ANGLIA SQUARE, NORWICH

**Rebuttal Proof of Evidence –
Response to Norwich Society – Jon Boon (NS1)
"Building for Life" Assessment**

LPA REF. 18/00330/F
PINS REF. APP/G2625/V/19/3225505

REBUTTAL: Norwich Society, Building for Life 12

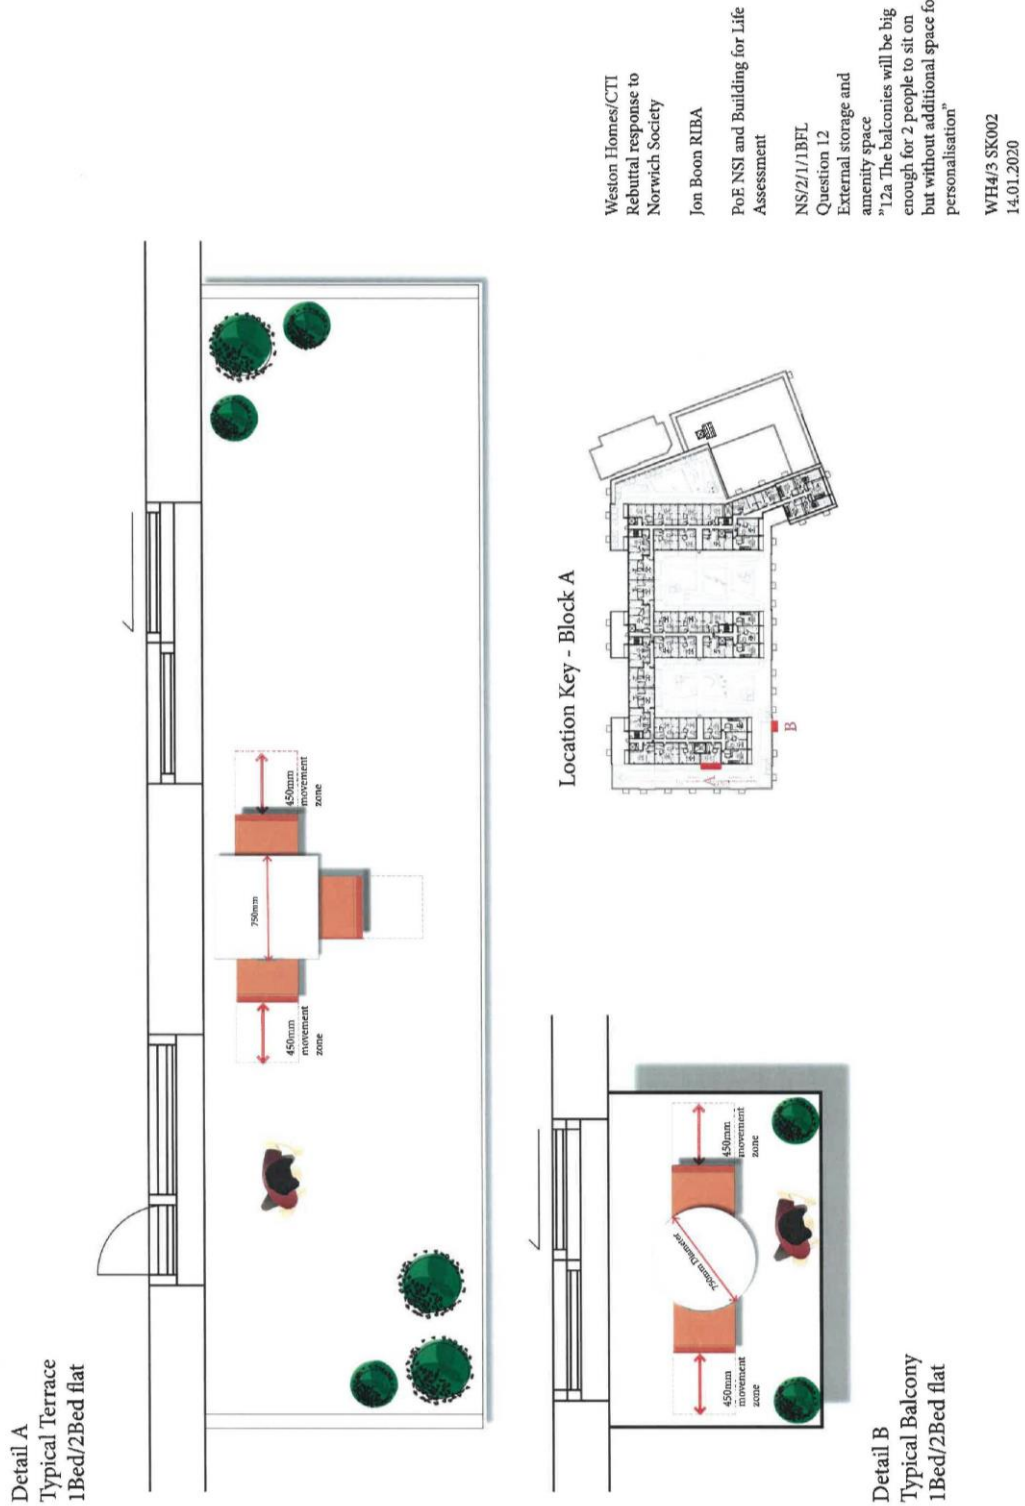
17.2 NS state, *'The balconies will be big enough for two people to sit on but without additional space for personalisation. However, residents have access to very large shared podium gardens. The waste storage is well considered and will not undermine the quality of the public realm'*.

17.3 In addition to the public realm and private gardens, residents of the new development will also have access to private space, balconies are provided to most apartments, and private terraces are included for apartments which look out onto the podium decks. The provision includes a minimum area of 5m² and 7m² where the design calls for feature balconies. The private terraces are larger still. The sketch included on the following page demonstrates how residents can personalise these with appropriate furniture and planting.
